Community Development Authority MEETING AGENDA

APPLICANT/PROJECT: Robert Gosse with the Sigma Group / Denali Ingredients Waste Water Treatment Addition

REQUEST: Use, Site and Architecture approval for a 2,109 square foot addition for Denali Ingredients located at 2400 S. Calhoun Road.

**CITY OF NEW BERLIN
DEPARTMENT OF COMMUNITY DEVELOPMENT
COMMUNITY DEVELOPMENT AUTHORITY STAFF REPORT**

SCALE:	1"=20'
PROJECT NO:	21341
DESIGN DATE:	3/23/23
PLOT DATE:	4/6/2023
DRAWN BY:	----
CHECKED BY:	----
APPROVED BY:	----
SHEET NO:	C101

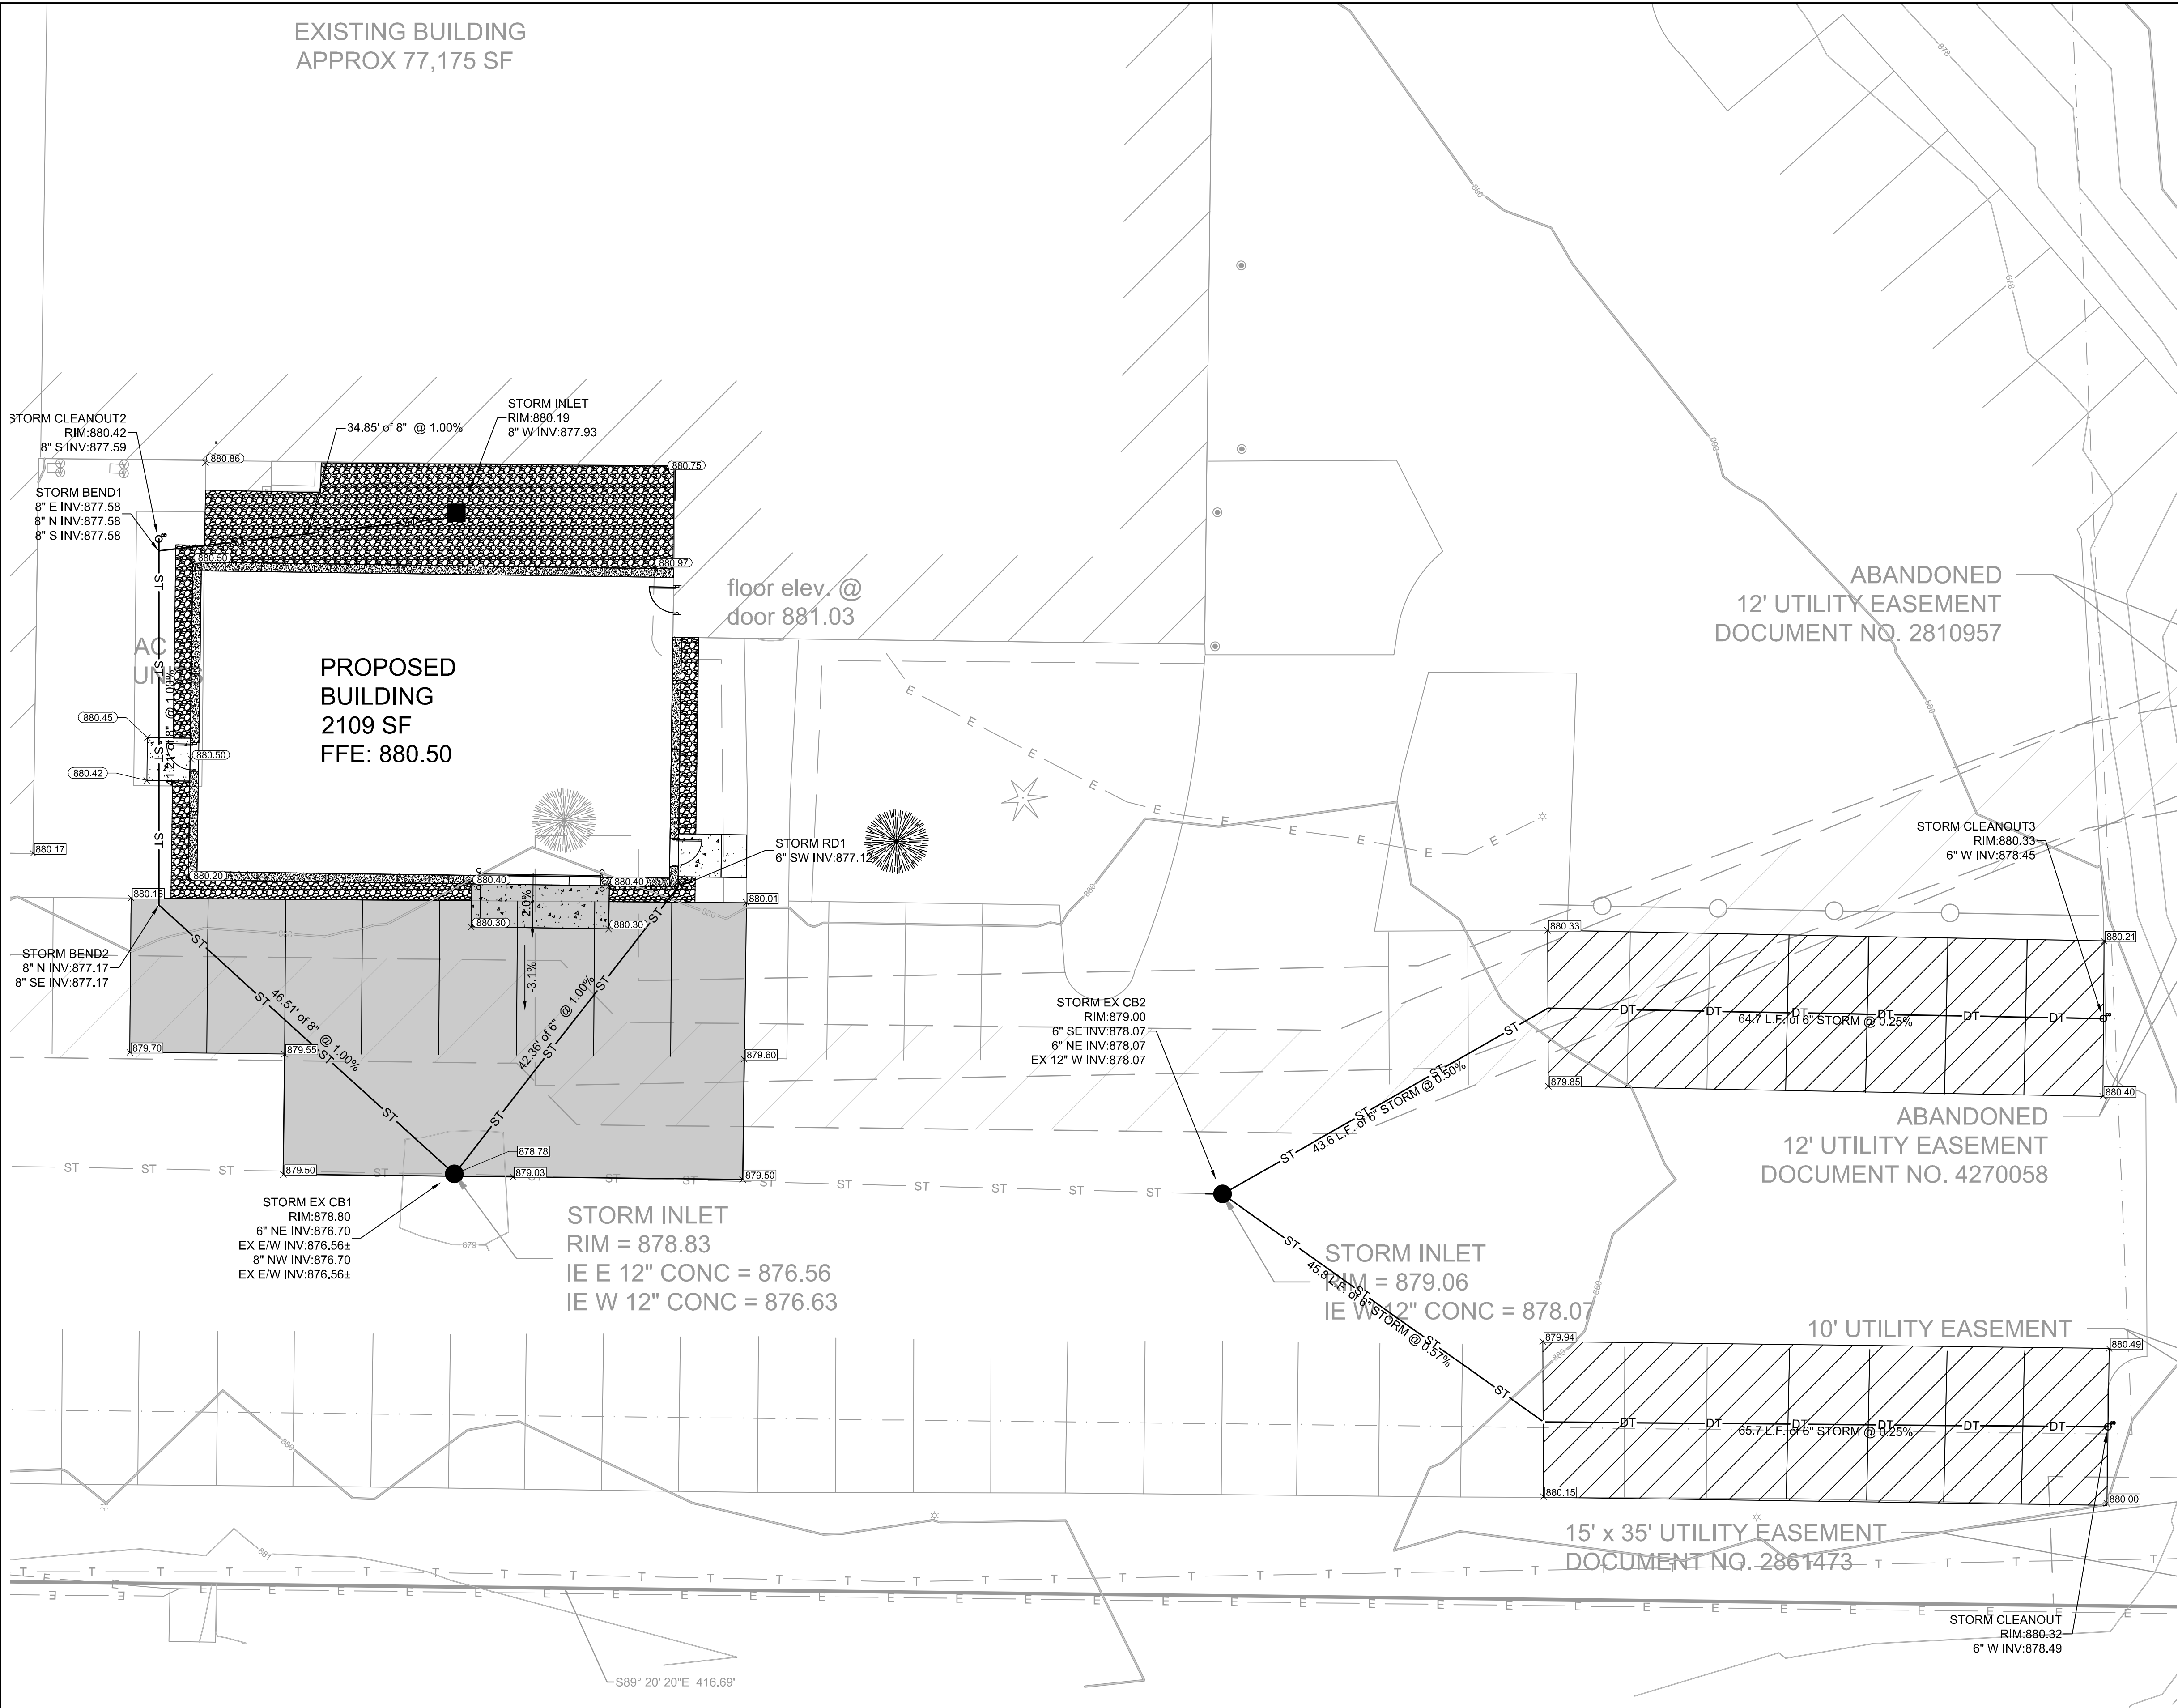
- 5. Engineering:**
- a. Per 275-57A(7)(e)(3): Wheel stops, continuous curbs, and/or bollards shall be located a minimum of four feet from any structures, buildings, walls, or plant material, excluding ground cover, to prevent a vehicle from driving onto the landscaped area or hitting any structure or plant material at the edge of a parking area.

- i. Consider adding the wheel stops and stripping the parking stalls adjacent to the building longer to account for the 4' building parking setback.
 - b. The applicant is proposing parking in front of the overhead door. Provide more detailed information on how frequently this door is used and how will it be controlled so the exit is not blocked.
